Bid Bulletin #1

PROJECT: Northeast Community College
Applied Technology Building, Physical Plant Building, Sitework

DATE: July 3, 2013

PHYSICAL PLANT / APPLIED TECHNOLOGY BUILDINGS CIVIL PACKAGE NORTHEAST
COMMUNITY COLLEGE
801 East Benjamin Avenue
Norfolk, NE 68702-0469
BCDM Project No. 3527-01

SHEET C2-5, WATER MAIN PLAN & PROFILE STA. 330+00 TO STA. 336+00

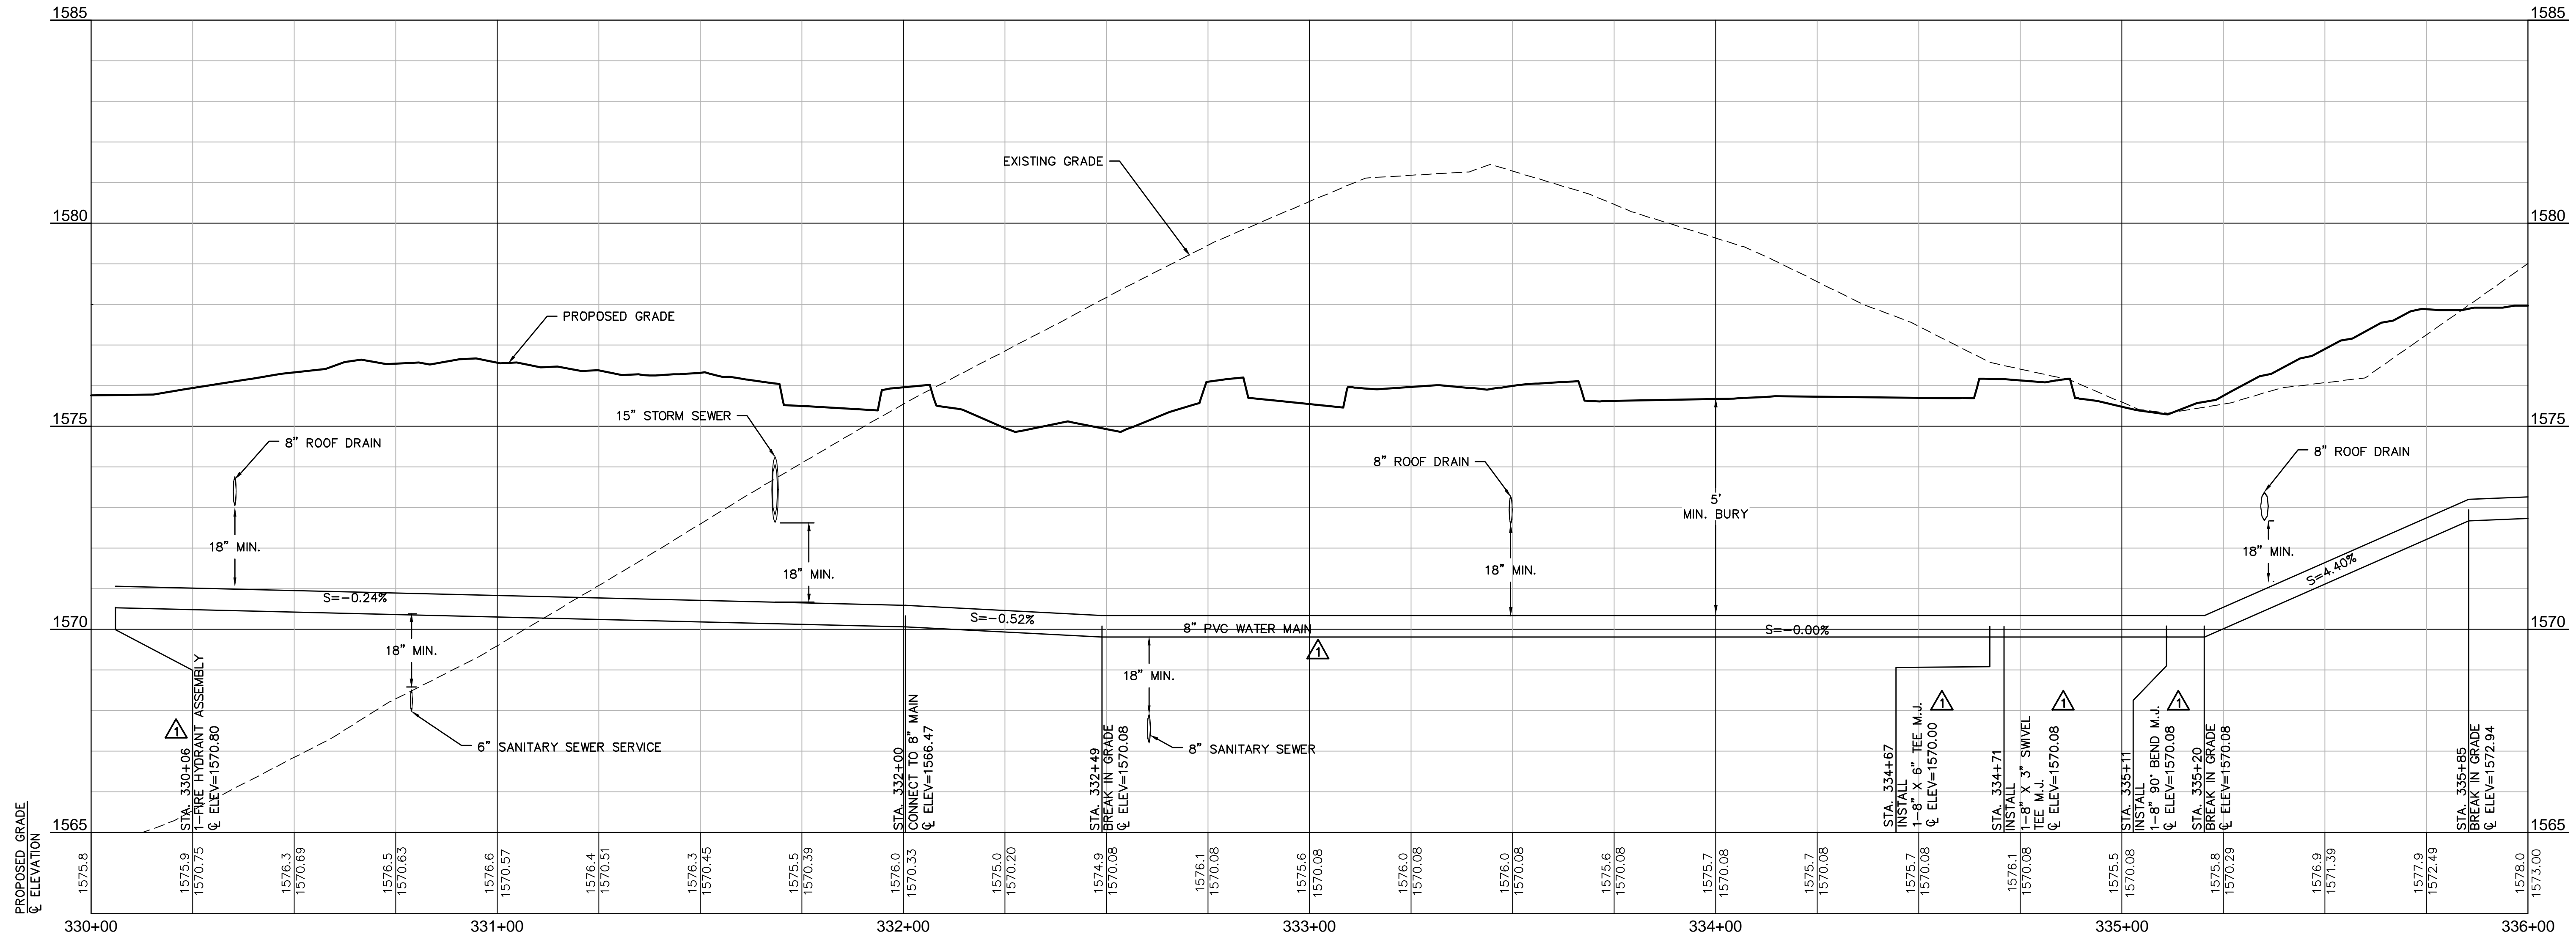
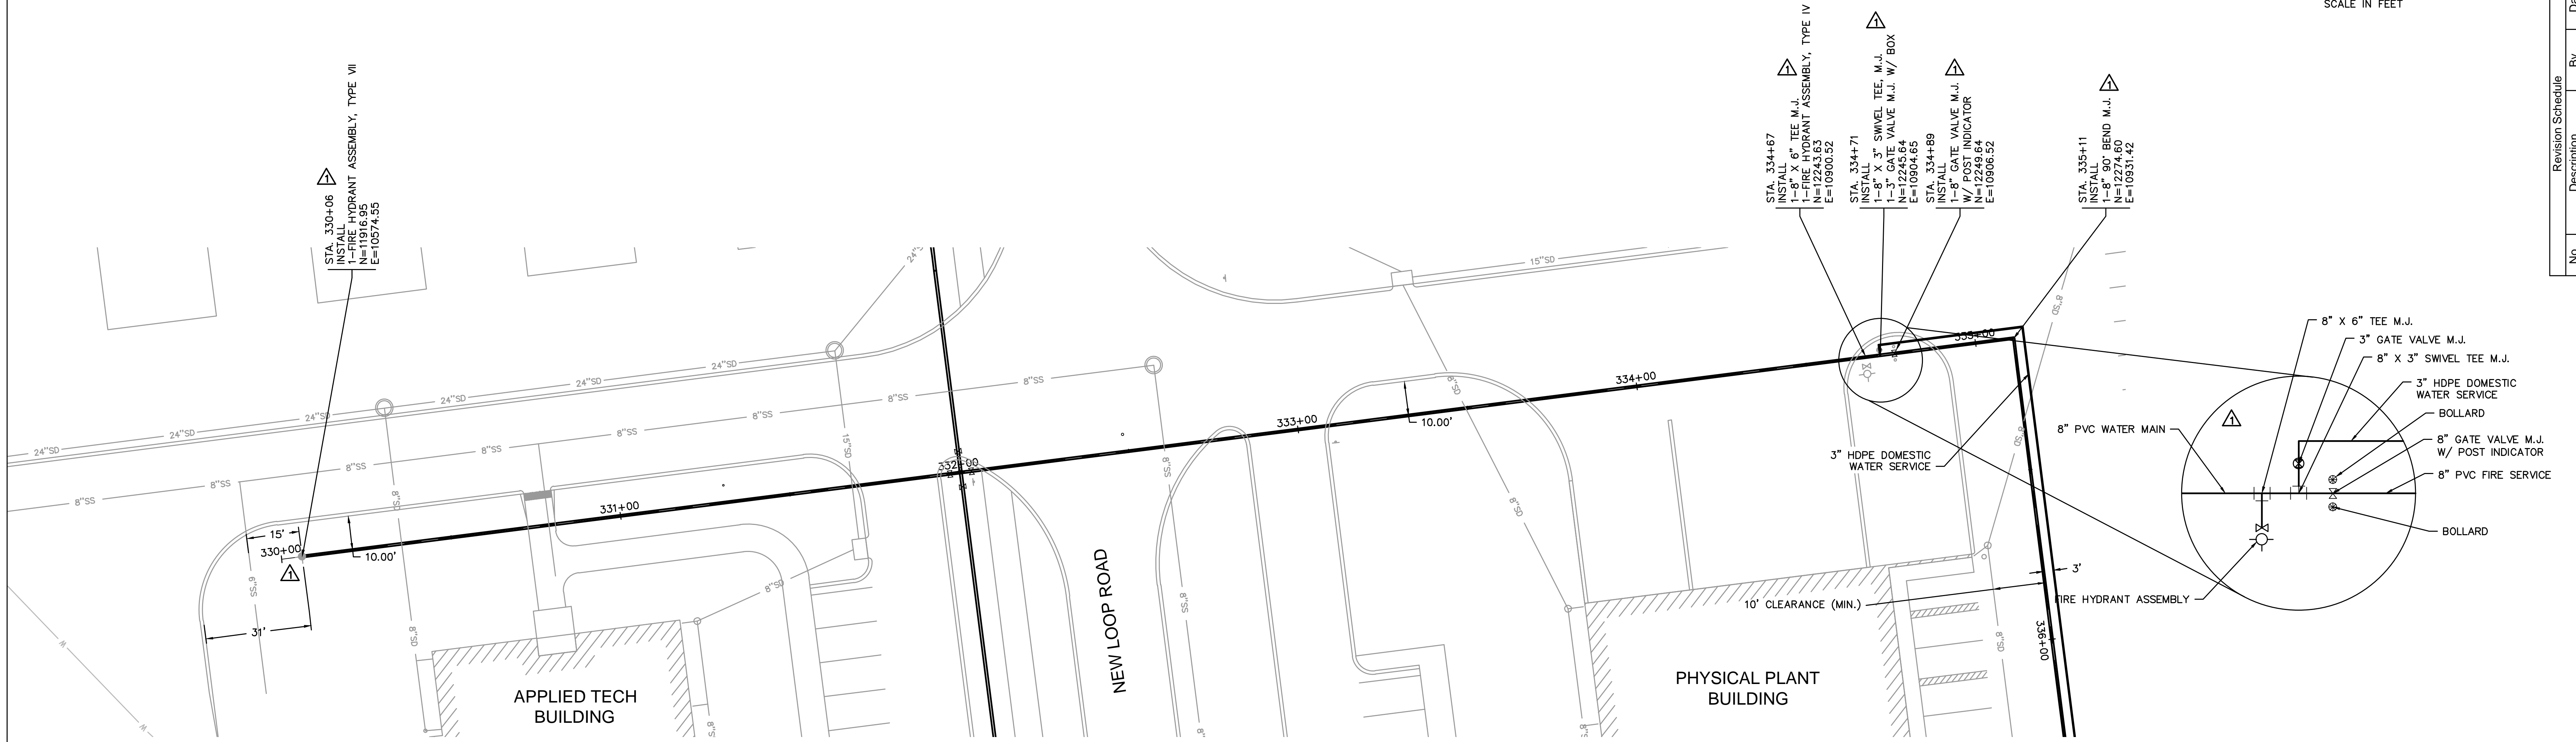
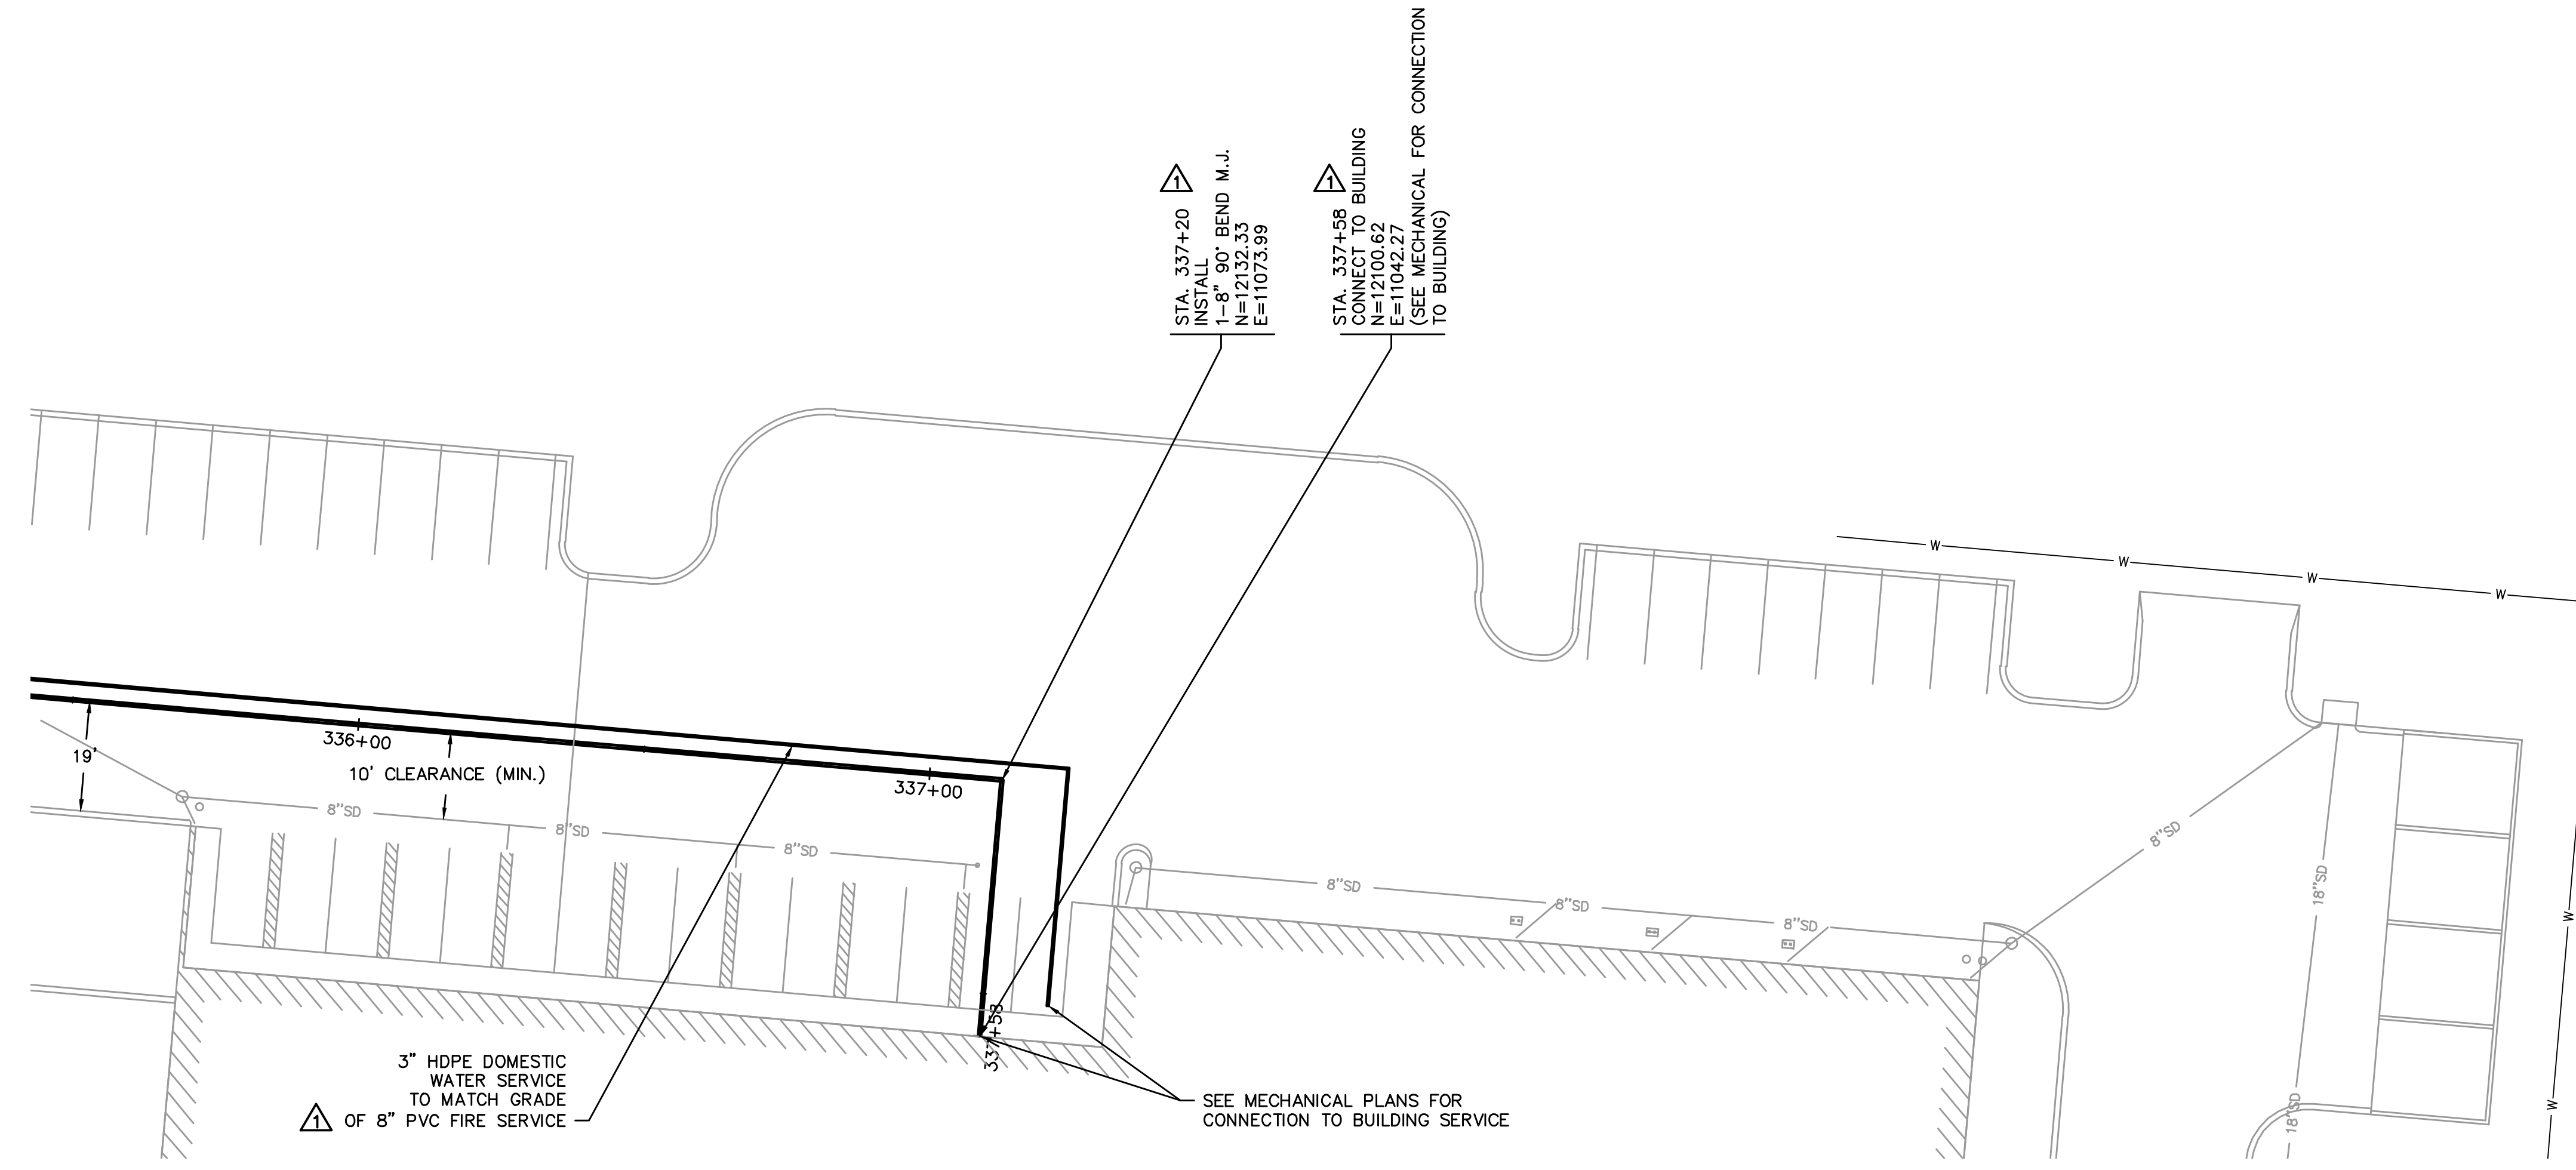
- a. Replace sheet in its entirety with the attached sheet C2-5.
- Size of pipe and fittings changed from 6" to 8" as shown on the revised sheet.
 - Location of fire service and domestic service changed as shown on the revised sheet to accommodate building connection locations.
 - Fire hydrant location changed from Sta. 330+00 to Sta. 330+06 to maintain horizontal clearance from additional sanitary service.

SHEET C2-6, WATER MAIN PLAN & PROFILE STA. 336+00 TO STA. 337+65:

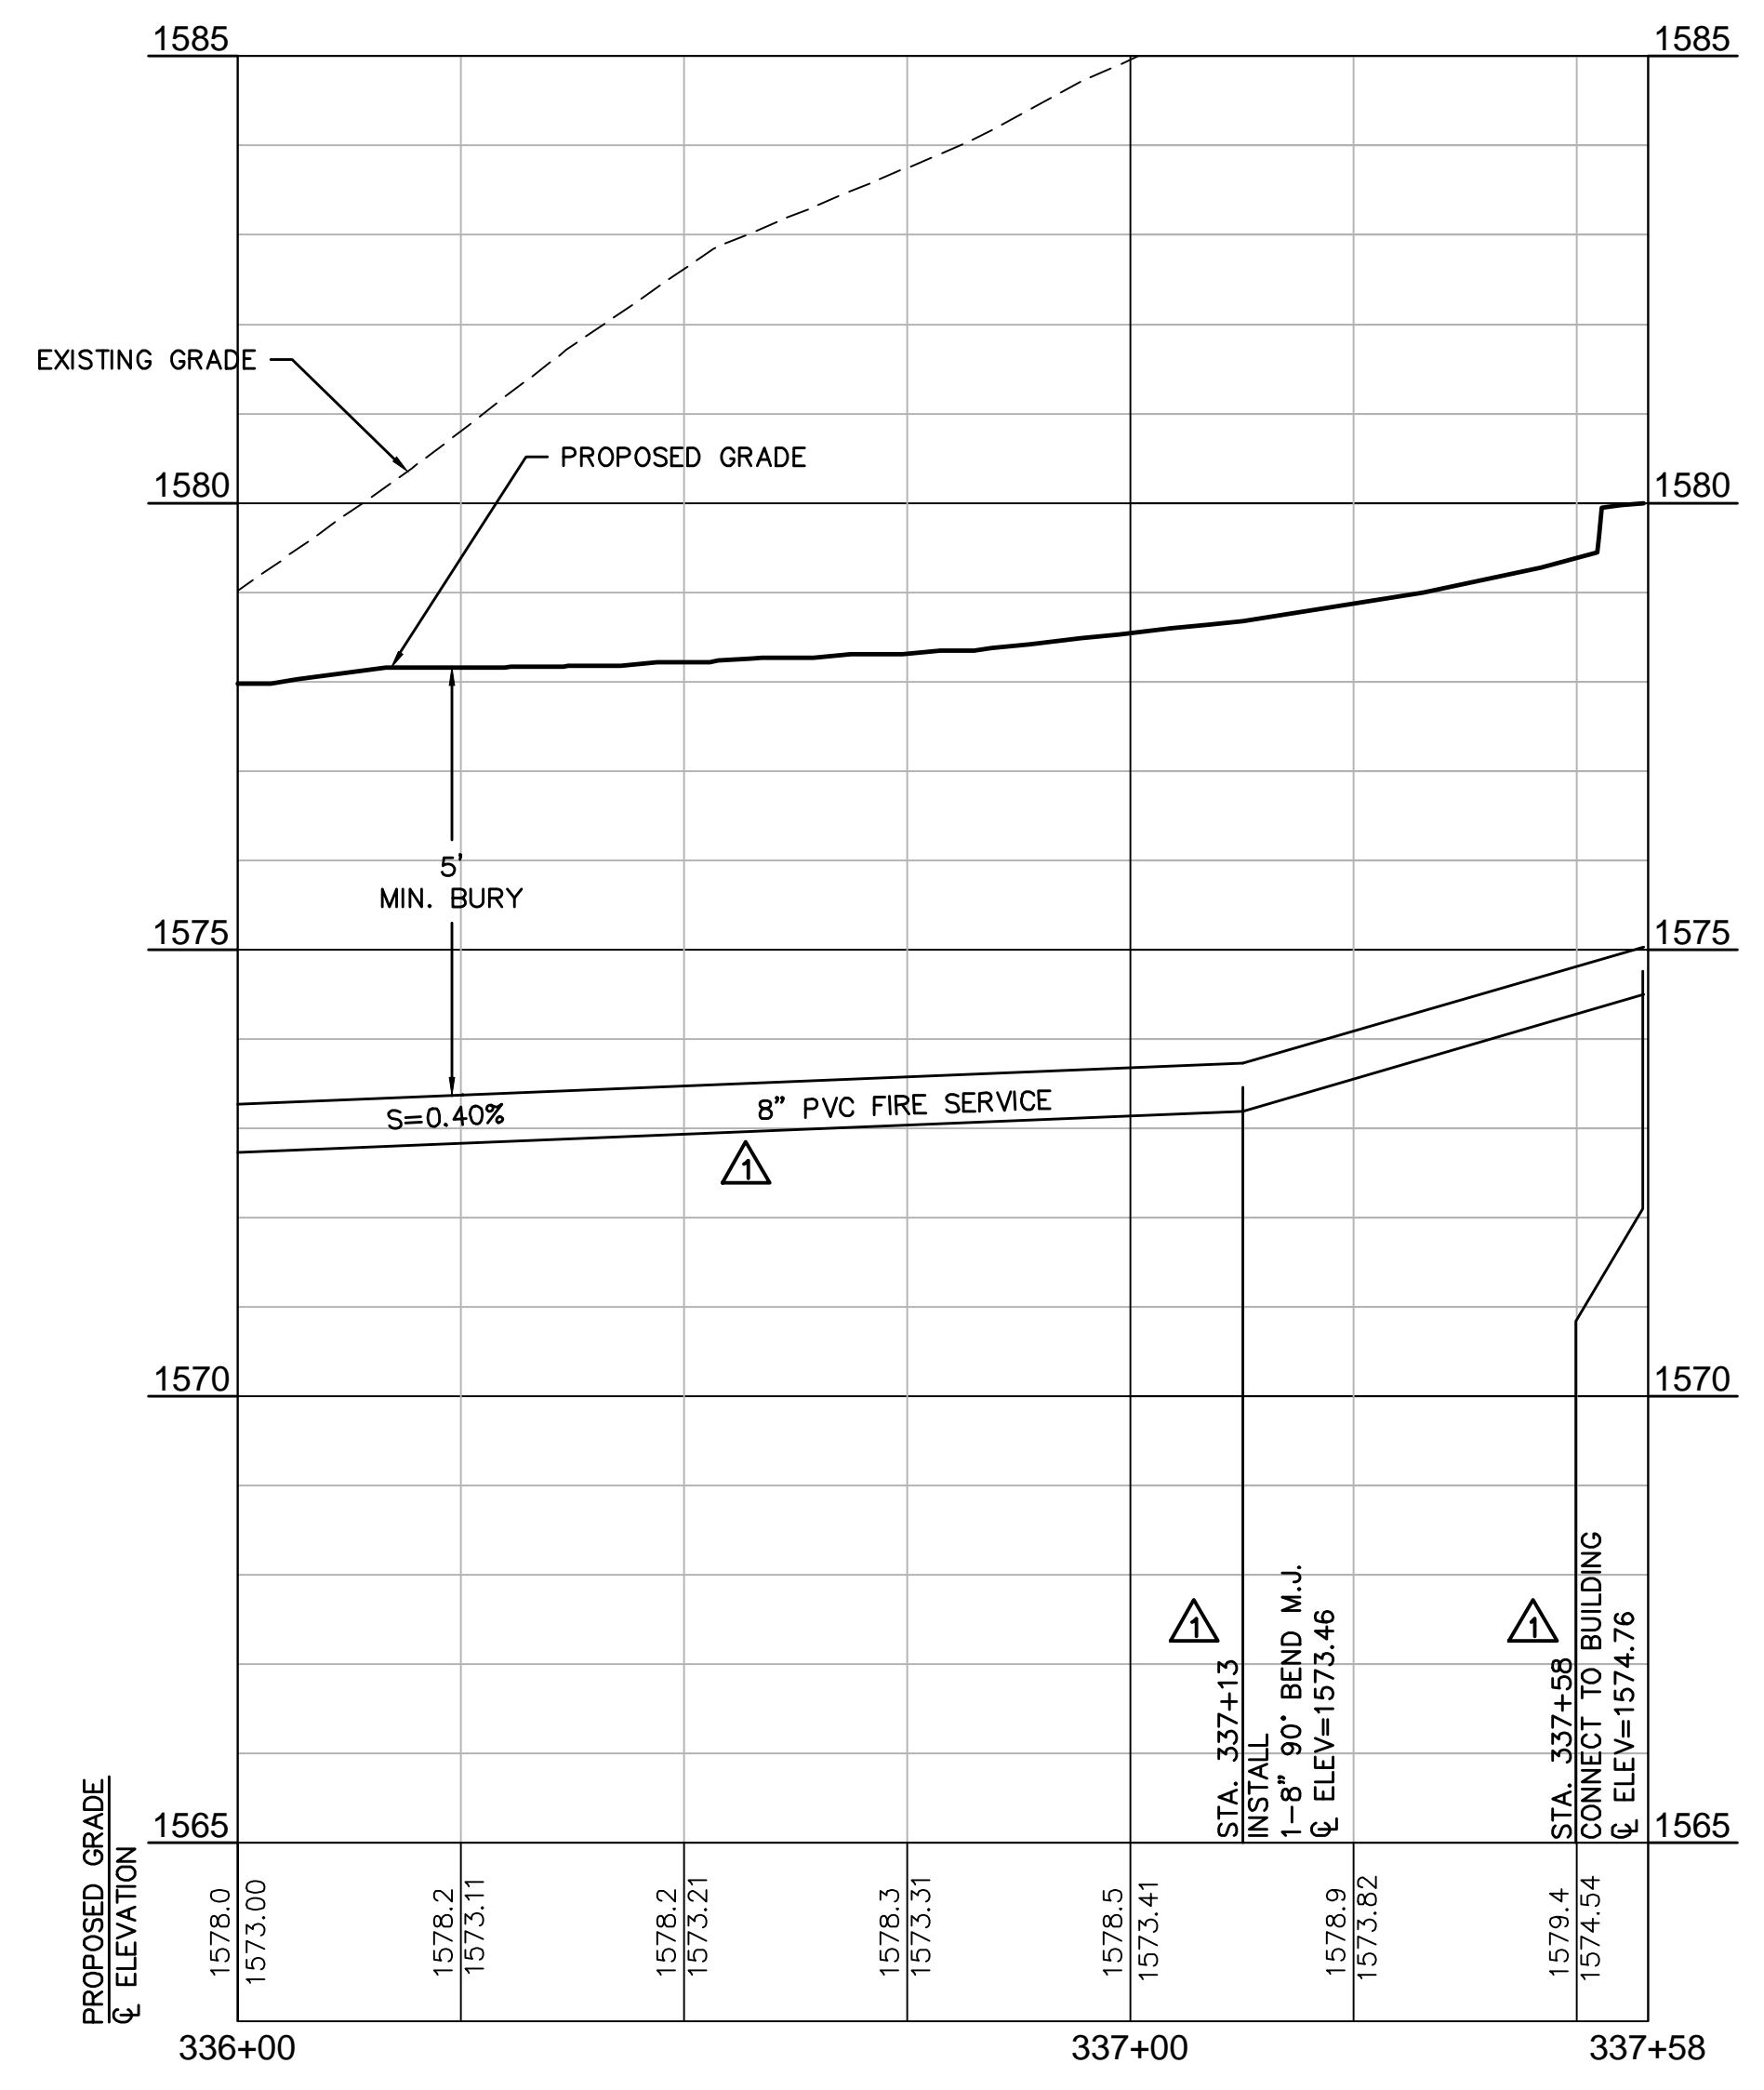
- a. Replace sheet in its entirety with the attached sheet C2-6.
- Size of pipe changed from 6" to 8" as shown on the revised sheet.
 - Location of fire service and domestic service changed as shown on the revised sheet to accommodate building connection locations.
